**Subject: Beaver Valley Power Station, Unit Nos. 1 and 2
BV-1 Docket No. 50-334, License No. DPR-66
BV-2 Docket No. 50-412, License No. NPF-73
Partial Withdrawal of Beyond Scope Issue (BSI)-26 Contained in
License Amendment Request Nos. 296 and 169, Improved Standard
Technical Specification Conversion**

BVPS UNITS 1 & 2 ITS CONVERSION LICENSE AMENDMENT REQUEST (LAR) Nos. 296 (UNIT 1) & 169 (UNIT 2) PARTIAL WITHDRAWAL OF BSI-26 CHANGE NOTES

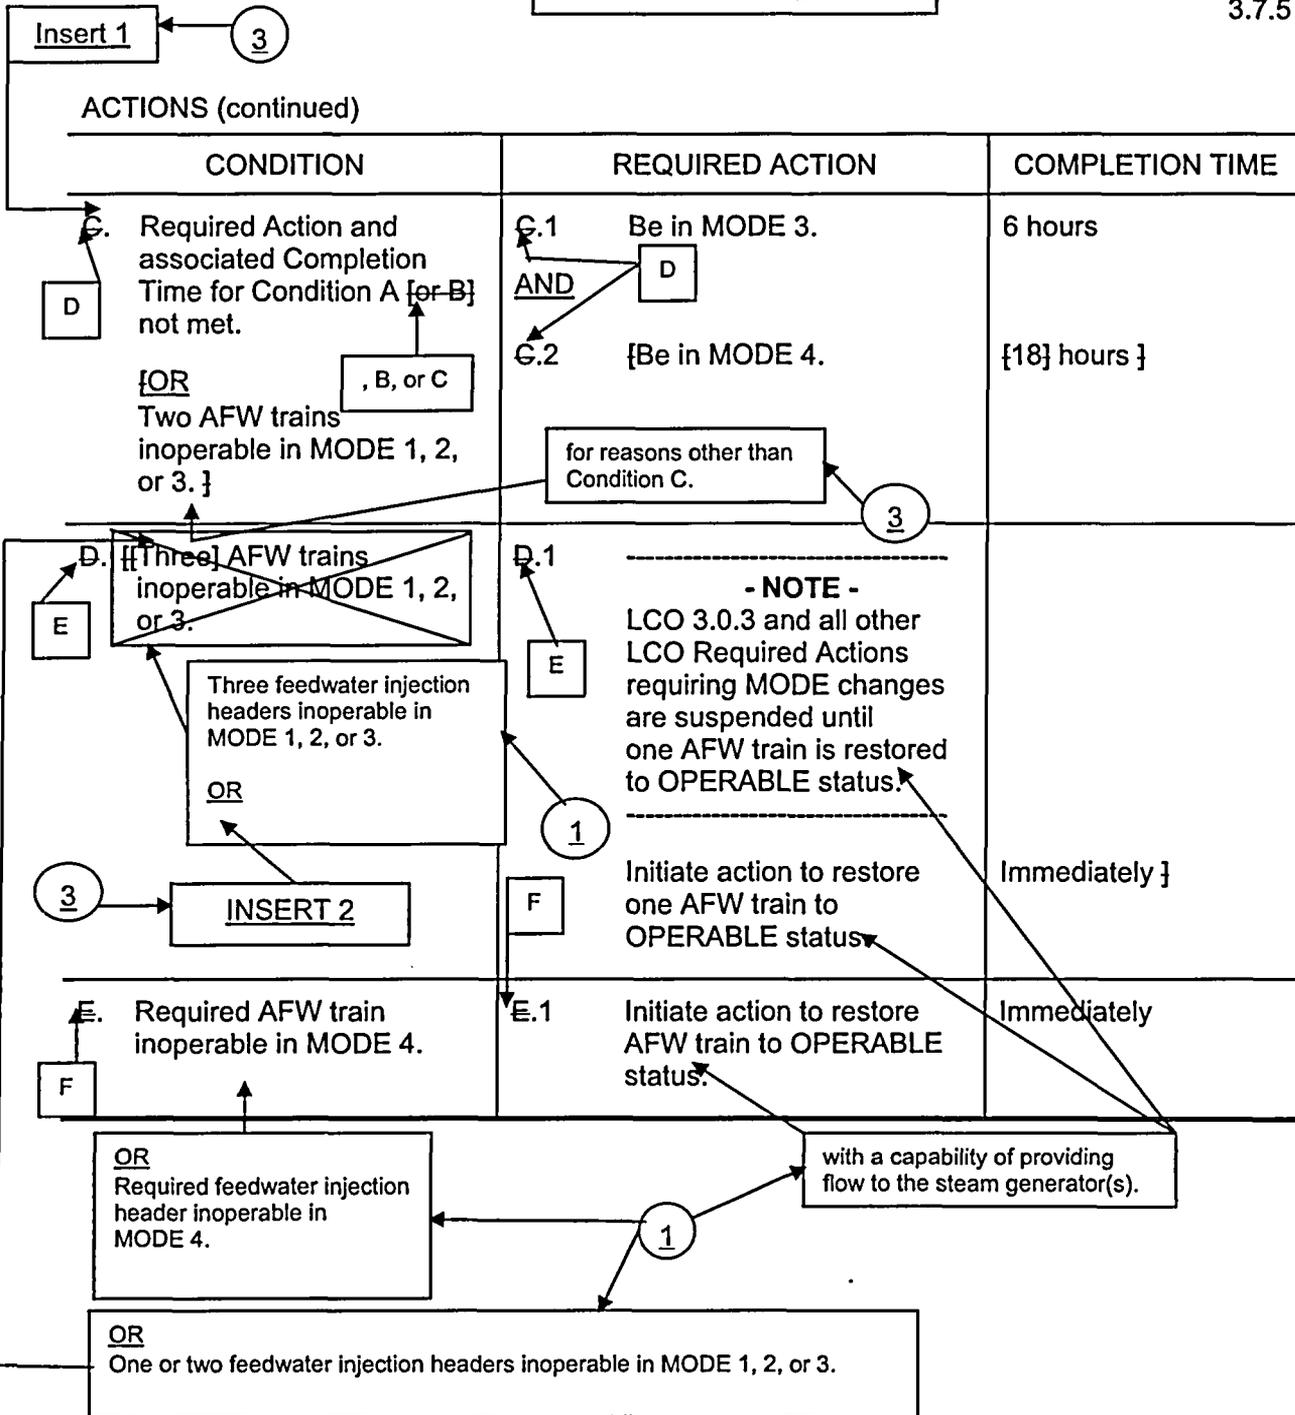
1. Page 17 is a page from NUREG-1431 (the standard Technical Specifications (TS) for Westinghouse plants) marked-up to show changes proposed by Beaver Valley Power Station (BVPS). On Page 17 Action Condition D was modified to delete an insert of a proposed new condition (for 3 inoperable AFW trains) and a note which made the proposed condition for 3 inoperable Auxiliary Feedwater (AFW) Trains only applicable when the turbine-driven AFW train was inoperable solely due to one inoperable steam supply line. The deletion of the proposed condition for 3 inoperable AFW Trains and modifying note from Action Condition D eliminates the action to place the affected unit in Mode 4 relying on the turbine-driven AFW pump with a single operable steam supply. In addition, the deletion of the proposed new condition for 3 inoperable AFW trains results in the Actions of the AFW Improved Technical Specification (ITS) being more consistent with the current BVPS TS.

2. Page 20 contains inserts for the proposed BVPS AFW ITS. On page 20, Insert 2 (intended for AFW Action Condition E on page 17) is revised to delete a proposed note that modified Action Condition E. The proposed note modified the standard Action Condition for 3 inoperable AFW Trains such that the condition was only applicable when the turbine-driven AFW train was inoperable for reasons other than one inoperable steam supply line. The deletion of the proposed note from Action Condition E results in the condition for 3 inoperable AFW Trains being applicable when the turbine-driven AFW Train is inoperable for any reason. Action Condition E requires the affected unit to restore one train of AFW to operable status prior to taking any action to place the unit in Mode 4. In addition, the deletion of the proposed note modifying Action Condition E results in the Actions of the proposed BVPS AFW ITS being more consistent with the current BVPS TS.

3. The AFW ITS Bases pages 106 and 107 are modified to delete the inserted text describing the proposed Action Condition for 3 inoperable AFW Trains and associated notes described in Items 1 and 2 above.

4. The current BVPS TS page 223 and associated insert page 225 were revised to show the deletion of the proposed AFW Action Condition and associated notes described in Items 1 and 2 above. This includes the deletion of Inserts 3 and 4 on page 225.

5. Pages 274 and 275 contain discussions of changes (DOCs) for the changes made to the current BVPS AFW TS. These pages were revised to delete DOC M.1 which discussed the proposed changes (Items 1 and 2 above) that were deleted from the BVPS ITS conversion documentation.
